THE NATIONAL GRID COMPANY plc
GRID CODE REVIEW PANEL
GENERIC PROVISIONS WORKING GROUP

1. This paper proposes revision of the Grid Code to clarify the obligations on Generators utilising technology other than synchronous machines and on operators of DC Converter Stations. The Generic Provisions Working Group includes representatives nominated by Generators, Transmission Operators, Distribution Network Operators, British Wind Energy Association (BWEA) and wind farm developers. Also Ofgem is present as an observer. The Working Group members are listed in Appendix 1.
2. Although wind turbine manufactures were not present on the group, National Grid consulted with five large European manufacturers namely NEG Micon, Bonus Energy, Vestas, Enercon and GE Wind. To meet the manufacturers concerns on commercially sensitive information, National Grid was obliged to agree confidentiality with these companies.

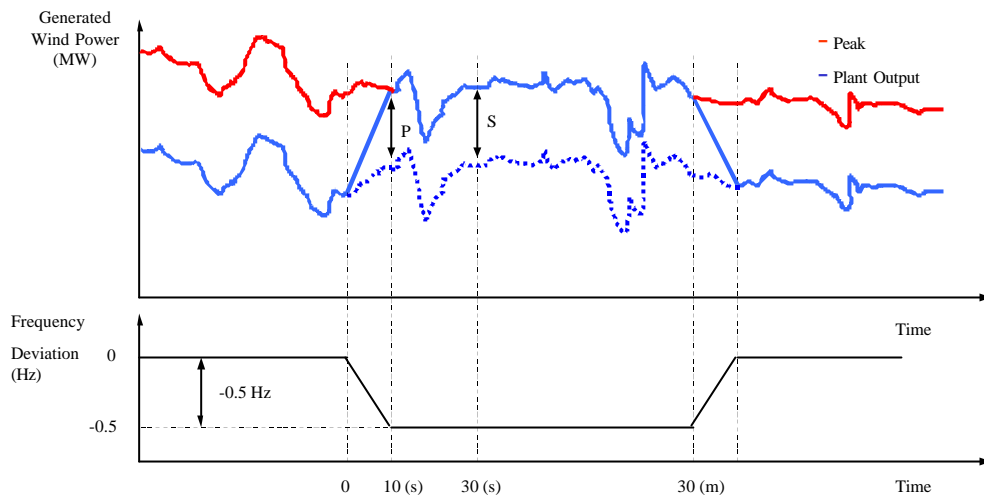
National Grid believes that it is reasonable to require the new generation technologies with completion dates after 1st January 2006 to provide a full frequency response capability. This view takes into account the following:

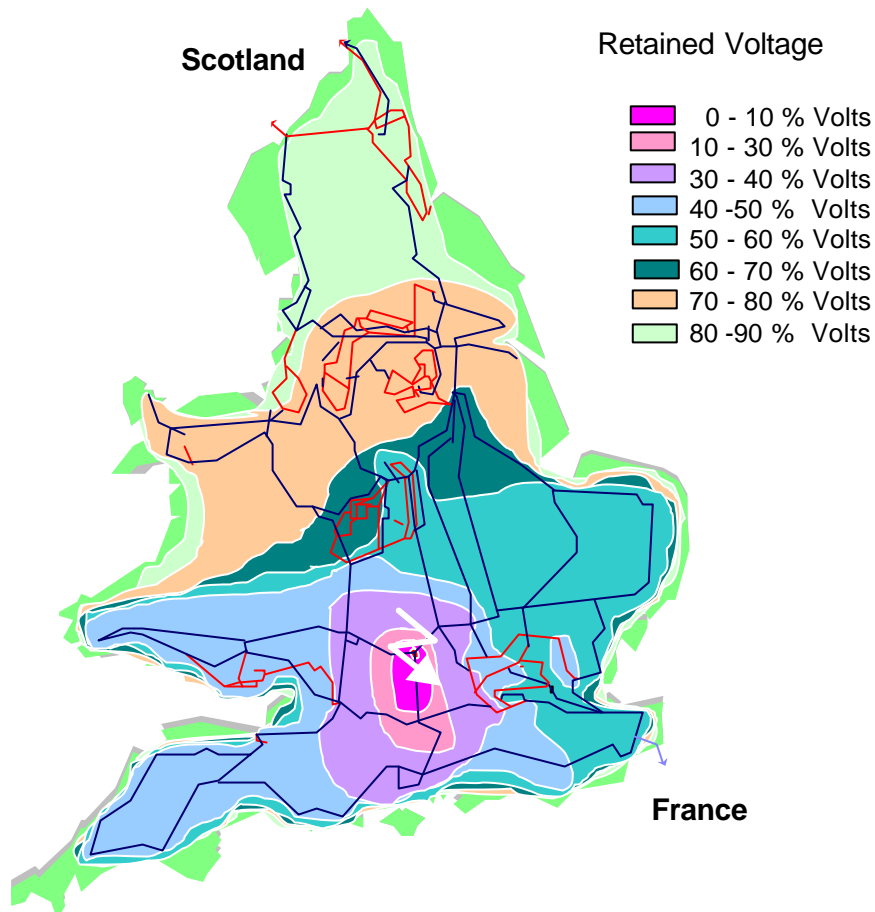
This is illustrated by the figure below where the voltage across the system during a 3 phase fault applied at Cowley 400 kV substation is shown. It can be seen that all substations in England and Wales are temporarily exposed to levels of less than 90 % of nominal voltage. The area where transmission system voltages are depressed below 10% covers a large part of Oxfordshire despite the presence of a large synchronous generator connected to the adjacent substation.

Some wind turbine technologies are reported to be susceptible to tripping even if the voltage transiently falls to levels as high as 70 %. The outcome of this would be significant volumes of generation would be lost. In this example all wind farms in the South of England and Wales would disconnect.

For clarity, the requirement to withstand faults on the transmission system has been added to the Grid Code. Without this ability there will either be a significant increase in the risk of customer disconnection spread across the whole country following a single fault, or there will be severe restrictions on the future concentrations of wind farm development in local areas.

Power Park Module Single Line Diagram

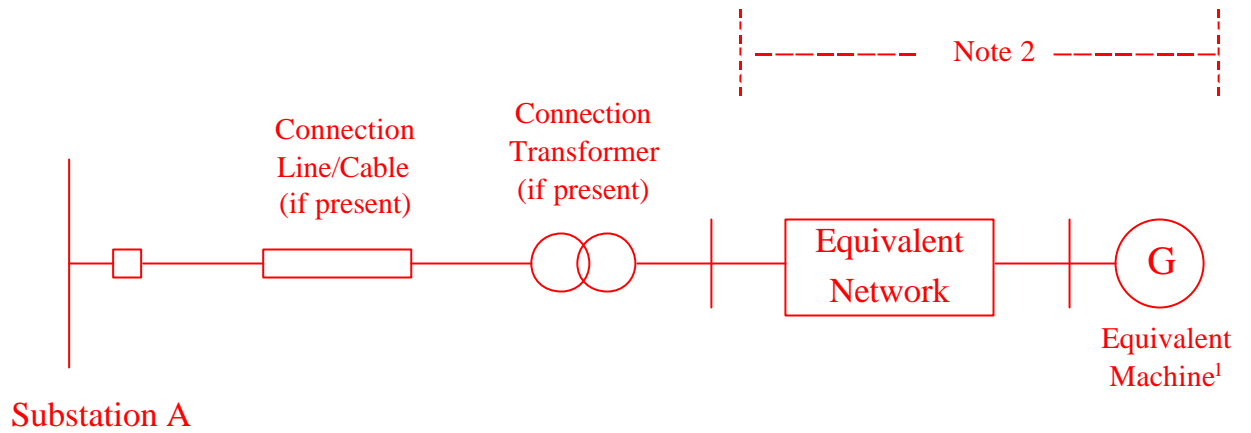
- PC.A.2.2.2 The **Single Line Diagram** (~~two~~ three examples are shown in Appendix B) must include all parts of the **User System** operating at **Supergrid Voltage**, and those parts of its **Subtransmission System** at any **NGC Site**. In addition, the **Single Line Diagram** must include all parts of the **User's Subtransmission System** operating at a voltage greater than 50kV which, under either intact network or **Planned Outage** conditions:-
